Access Compliance Report

Public Rights-of-Way

(Curb Ramps)

Intersection ID: 10026804	Main Street: FOREST_POINT_CR	Cross Street: N/A	Location: NW
ADA ID: 4F7A97848E3E	Ramp Type: PerpDiag	Initial Pass/Fail: Fail	Overall Compliance: No
Severity Score: 26.25			
Codes/Mitigation Info/Possible Solution		Field Measurements/Component Compliance

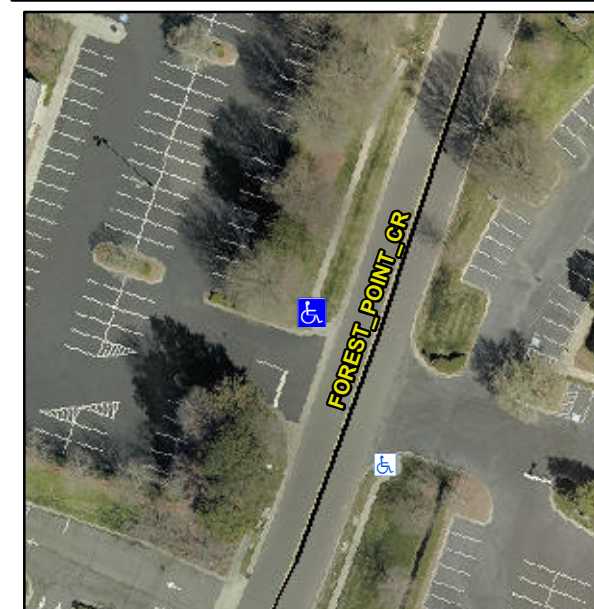
Not Found, R304.2.2, R304.5.3

Compliance	Description	Data	Compliance	Description	Data
N/A	Ramp Length (in)	51.0	No	Ramp Slope (%)	12.3
Yes	Ramp Width (in)	53.0	No	Ramp XSlope (%)	4.9
N/A	Flare Type LT	N/A	N/A	Flare Type RT	N/A
N/A	Flare Slope LT (%)	N/A	N/A	Flare Slope RT (%)	N/A
N/A	Flare Traversable LT?	N/A	N/A	Flare Traversable RT?	N/A
N/A	Landing Length (in)	N/A	N/A	DWS Provided?	N/A
N/A	Landing Width (in)	N/A	N/A	DWS Contrast?	N/A
N/A	Landing Slope (%)	N/A	N/A	DWS Length (in)	N/A
N/A	Landing X Slope (%)	N/A	N/A	DWS Full Width?	N/A
N/A	Landing Curb? (Y/N)	N/A	N/A	DWS Offset (in)	N/A
N/A	Shared Landing?	N/A			
N/A	Gutter Ponding?	N/A	N/A	Gutter Slope (%)	N/A
N/A	Gutter Lip Ht (in)	N/A	N/A	Gutter X Slope (%)	N/A
N/A	Painted X Walk1?	No	N/A	Painted X Walk2?	No
	X Walk 1 Direction	To SW		X Walk 2 Direction	To SE
N/A	X Walk 1 Width (in)	N/A	N/A	X Walk 2 Width (in)	N/A
	X Walk 1 Slope (%)	2.4		X Walk 2 Slope (%)	2.7
	X Walk 1 X Slope (%)	3.4		X Walk 2 X Slope (%)	0.7

Remove & Replace Curb Ramp With Two New Directional Ramps or Equivalent.
